## **ACTION TRANSMITTAL – 2022-03**

**SUBJECT:** Scope Change Request for Hennepin County CSAH 158 (Vernon Ave) Bridge Replacement

**To:** Metropolitan Council – Transportation Advisory Board (TAB)  
**From:** Jason Staebell, PE – Hennepin County Project Manager  
**Date:** October 20, 2021  
**Re:** CSAH 158 (Vernon Ave) Bridge Replacement Project – Scope Change Request

Figure 1

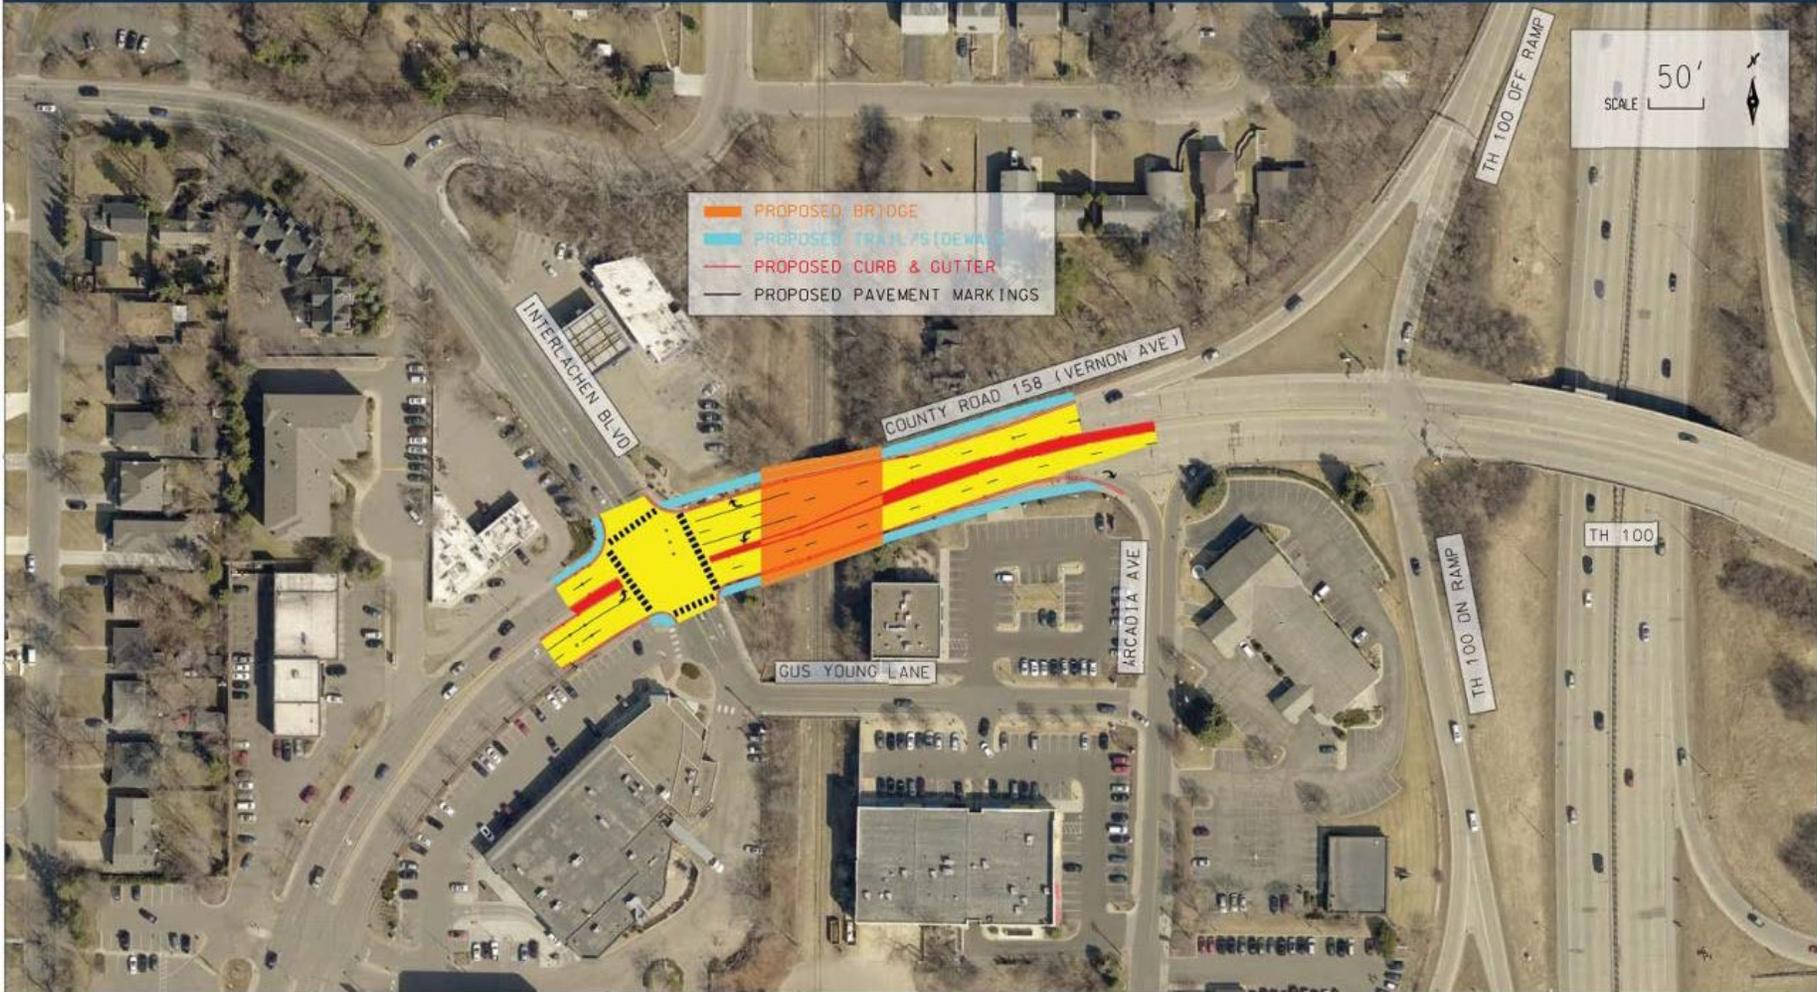
See Figure 1 for layout of expected scope at the time of the 2018 Regional Solicitation Application. See Figure 2 for a layout of the current scope.

Figure 2

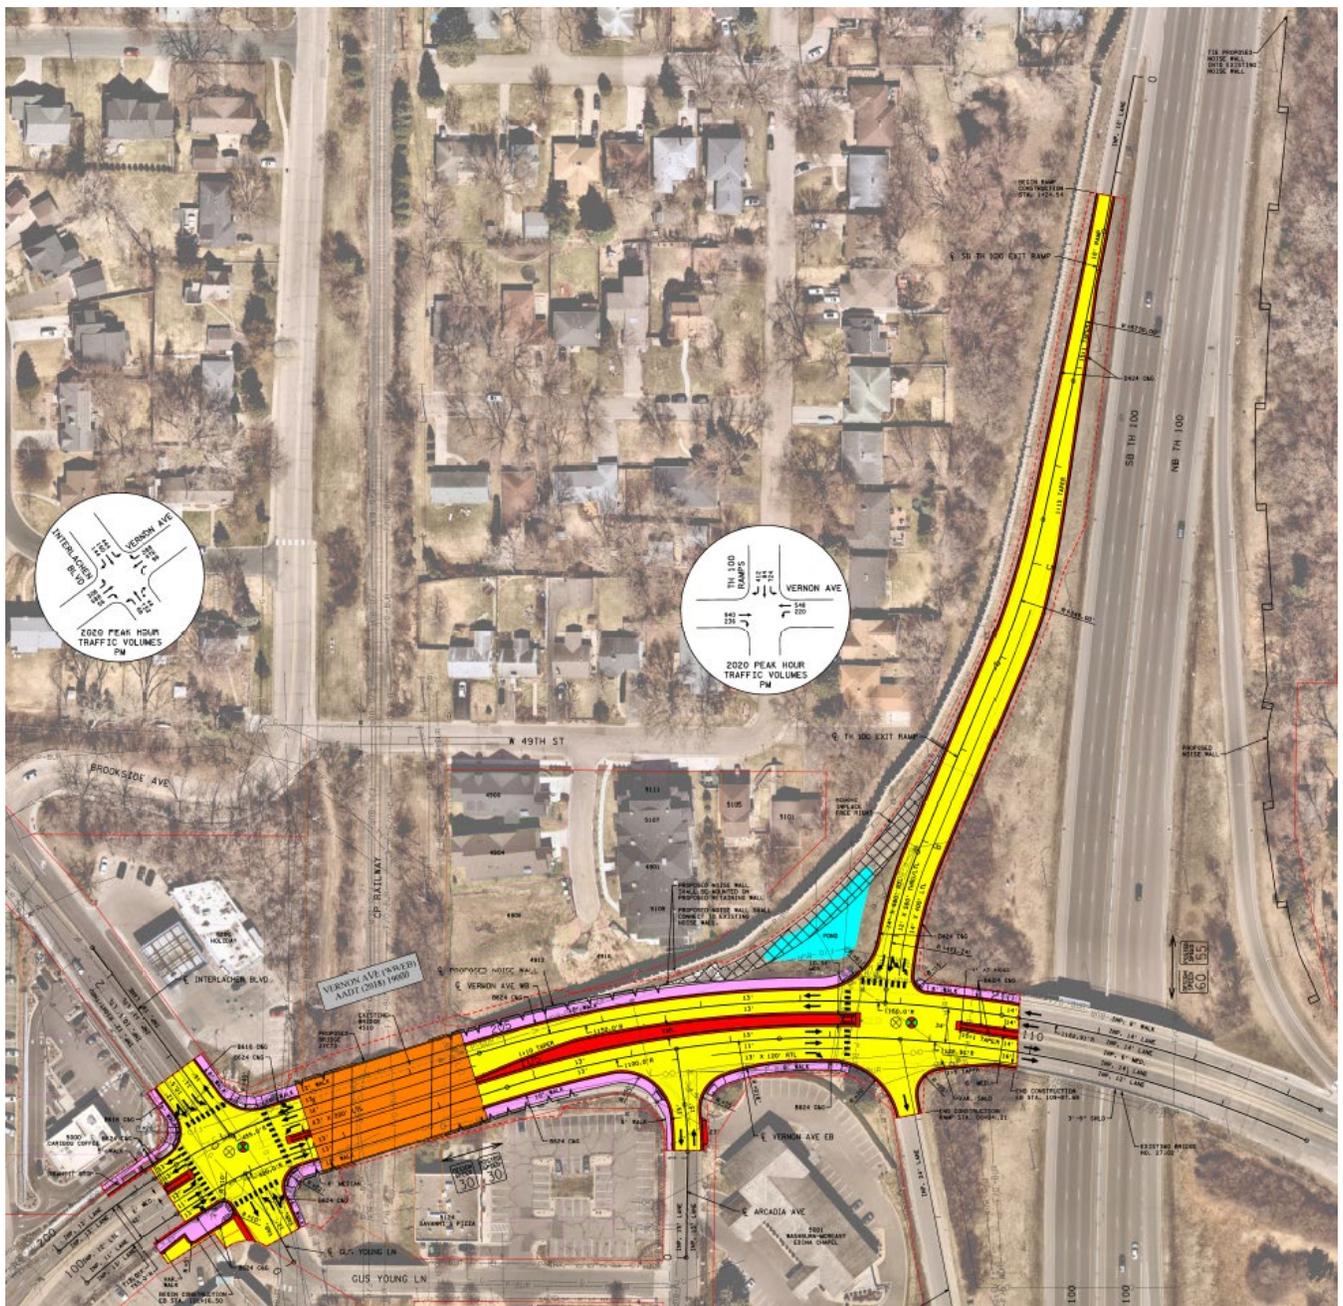
During the preliminary design phase, several design constraints dictated the need for the proposed work shown in Figure 2.

First, profile requirements caused the project to extend to the east. The CP Railway current standards for vertical clearance over their railway required a significant raise in the elevation of proposed Bridge No. 27C73 as compared to the existing 22 foot clearance for Bridge No. 4510. The current preliminary design satisfies the 23 foot minimum vertical clearance requirement over the existing CP railway as well as over a potential future track, which would be located 15 feet east of the existing track (centerline to centerline). The proposed profiles and clearance information can be seen in Figure 3: Vernon Avenue WB and EB Profiles.

On the west side of the project, these proposed profiles were able to tie into the existing roadway at essentially the same location as expected in the 2018 Regional Solicitation Application. However, on the east side of the project, the construction limits needed to extend considerably to the east in order to tie into the built environment. The profile would allow construction to end approximately 26 feet west of the existing bridge over TH 100 (Bridge No. 27102). To be considerate of future maintenance and lifespan concerns, the project was extended this additional 26 feet to match into existing Bridge No. 27102.

Second, the channelized right turn island from the SB TH 100 Exit Ramp is proposed to be removed to address existing safety concerns. Local public agencies have observed two issues with the vehicles traveling along this channelized right turn island: one) excessive speeds, two) poor compliance for the yield condition. In addition, bicycles are known to frequent this area, which presents a higher safety concern since vehicles may complete this turning maneuver at a relatively high rate of speed.

Third, roughly 825 feet of the SB TH 100 Exit Ramp is proposed to be reconstructed in order to accommodate longer left and right dedicated turn lanes. MnDOT required traffic modeling of the SB TH 100 exit ramp to determine if vehicles would queue onto the freeway in the build condition or in the 20 year future condition. It was found that while queuing was not expected to reach the freeway with build year volumes, the same could not be said for the 20 year future condition. Thus, MnDOT requires that the ramp be updated to accommodate the future condition.

Fourth, a noise wall is proposed on the east side of TH 100 due to the "Noise Requirements for MnDOT and other Type I Federal-aid Projects" effective since July 10, 2017. These requirements state, "*The noise analysis must include all areas that are affected by the project, including impacts from the project that occur beyond the official project limits/termini.*" and that ". . . *the analyst should extend the modeling limits at a minimum 500' or to a 'logical' termini point greater than 500' from the end of physical construction.*"

Fifth, the right turn lane along westbound Vernon Ave at Interlachen Blvd that was proposed in the 2018 Regional Solicitation Application was removed from the scope of the project. After extensive modeling of the project area, it was found that the benefits of right turn lane were not justified. The right turn lane would reduce vehicle delay at the intersection, however the reduction was relatively modest, especially in comparison to the improvement provided by the left turn lane. The four lane section is relatively uninviting and uncomfortable for people walking in the area, requiring a longer crossing time. A three lane section was determined to provide a better balance of needs between people walking and people driving. Overall, the removal of the right turn lane may be viewed as a modest reduction in benefits for people driving, however, a significant increase in benefits for people walking.

**Figure 4:** Noise Study Required Extents (500' radius)

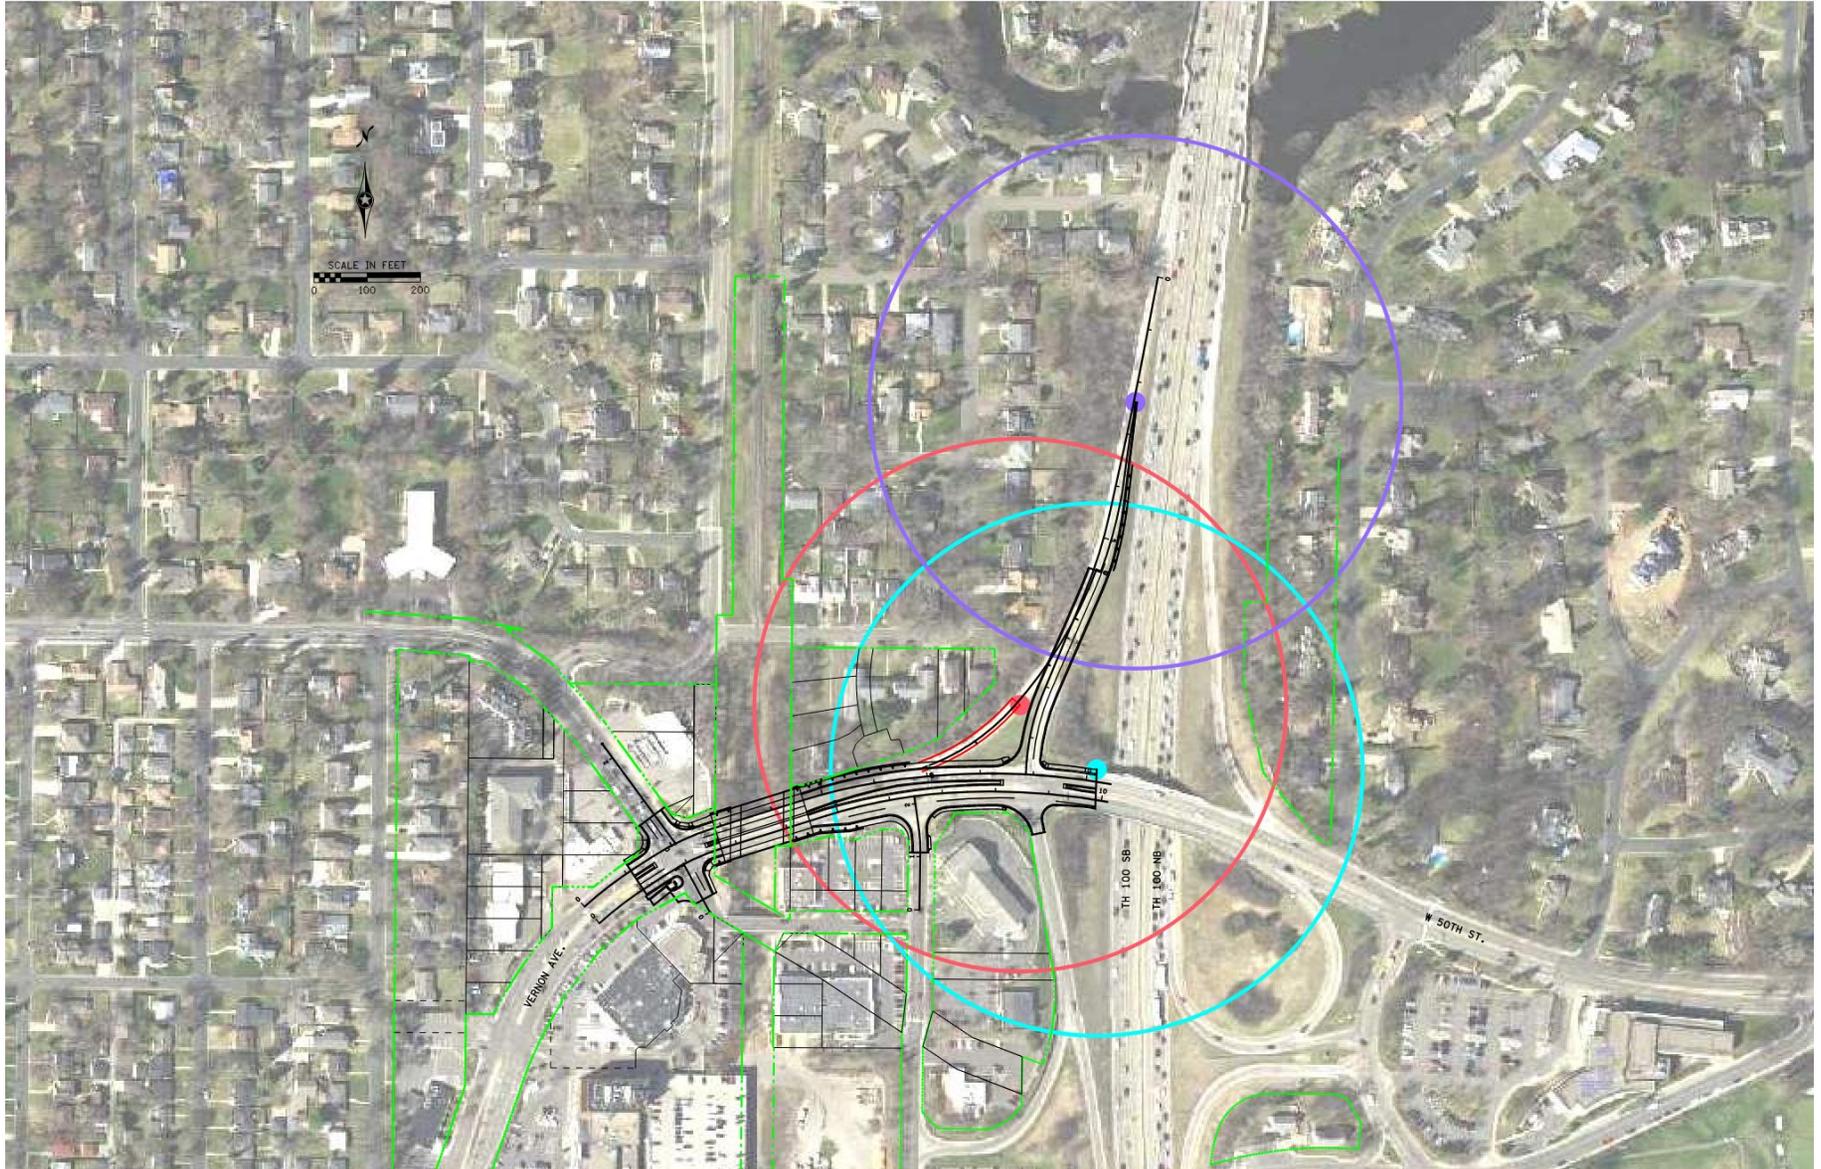
Figure 4 shows the extents of a 500 foot radius from three points, one) the edge of WB Vernon Avenue Construction, two) the edge of construction if the channelized right turn island was reconstructed, and three) the edge of reconstruction of the ramp.

As seen in Figure 4, even disregarding any construction on the SB TH 100 Exit Ramp or channelized right turn island, the noise study would be required to consider the homes just east of TH 100 based solely on the construction of WB Vernon Avenue. Those homes are within 500 feet of the proposed construction.
